# 2700 Westchester Avenue

## Final Environmental Impact Statement (FEIS)

Town/Village of Harrison,  
Westchester County, New York

# **FINAL ENVIRONMENTAL IMPACT STATEMENT (FEIS)**

Drawn: JJ  
Scale: 1" = 20'  
Date: 4/4/2022  
Project No: 20105  
2015-2040 FLOOD FLOOD.eyx  
Drawing No: FIG-1

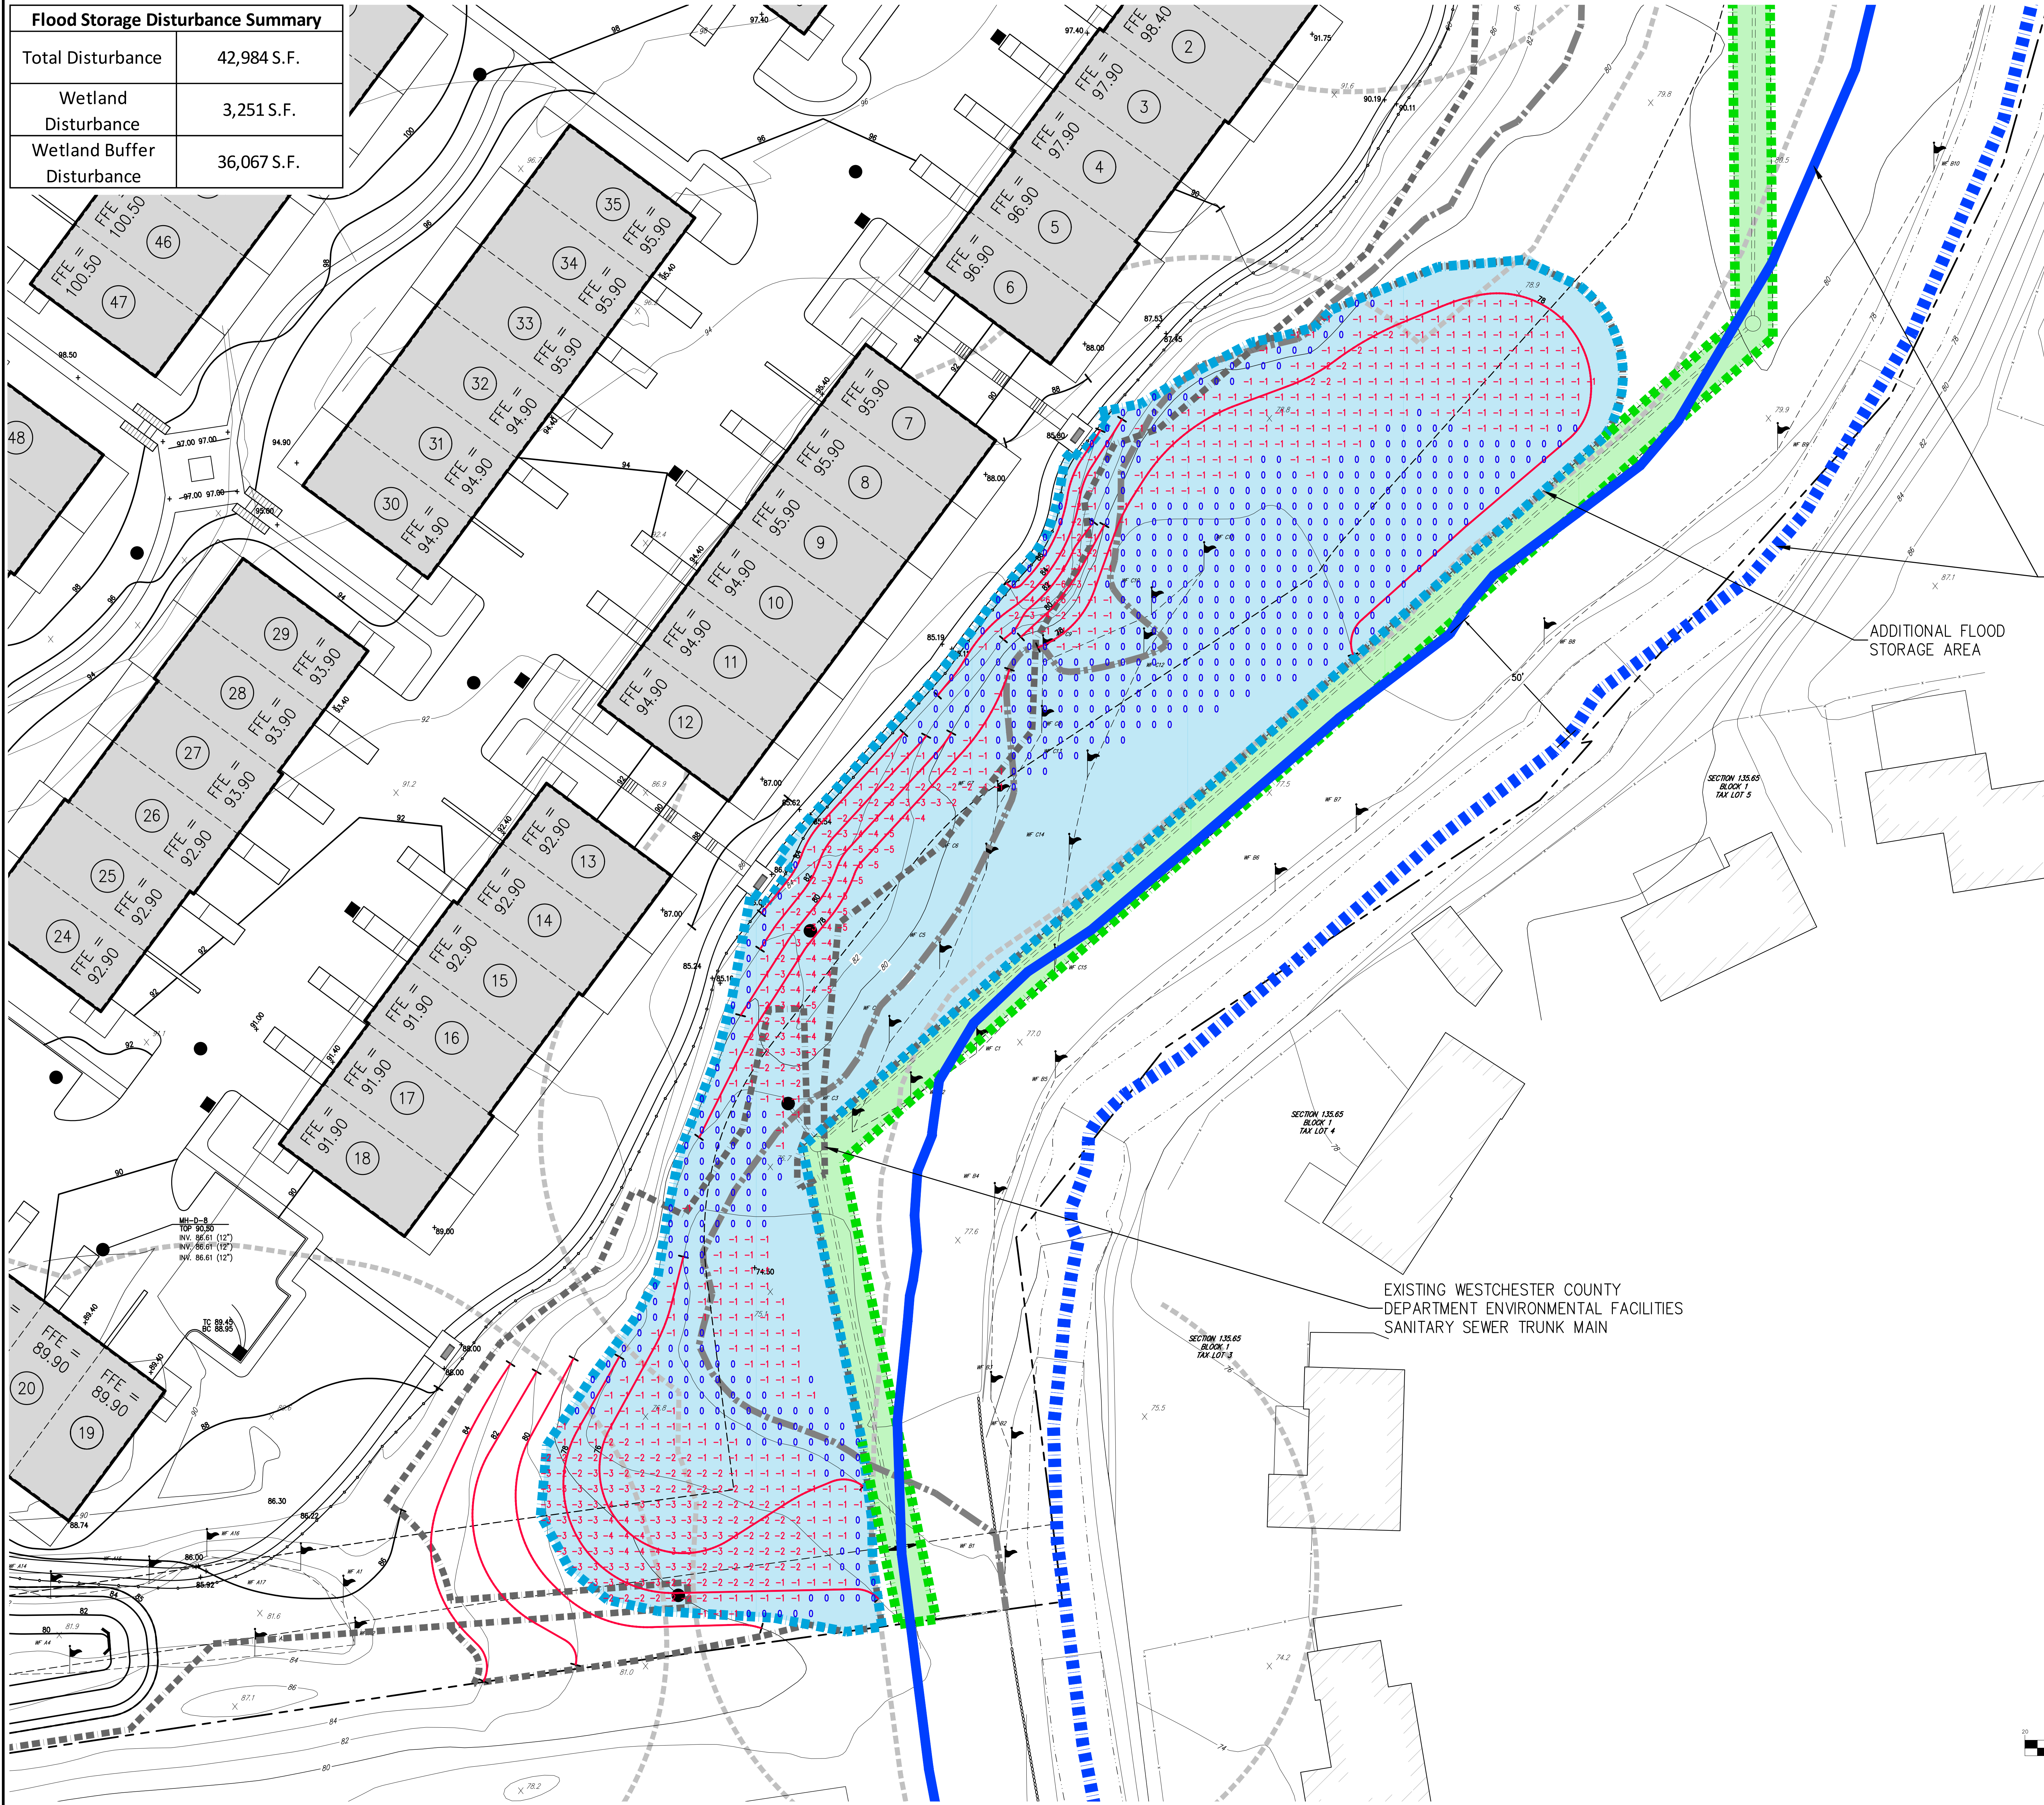
The regraded area depicted on Figure 1 would increase the potential flood storage in this area by approximately 1,100 cubic yards. This results in a total flood storage capacity of approximately 2,080 cubic yards, which is approximately 1.3-acre feet.
